POLARIS

RACING

MY21 600R Handlebar heater switch wired incorrect

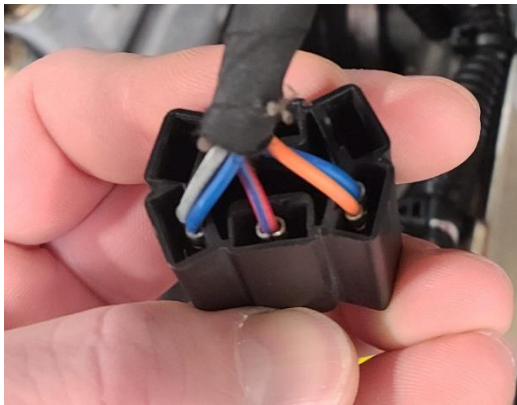
P1 and P3 connectors at the plastic plug for the handlebar High-Low heater switch need to be switched. Switch the Orange/Green & Blue wire plug position with the Blue/Red & Grey/White plug position in the plastic plug for the High-Low heater switch. Refer to below pictures for reference.

Stock incorrect wiring orientation

Correct wiring orientation
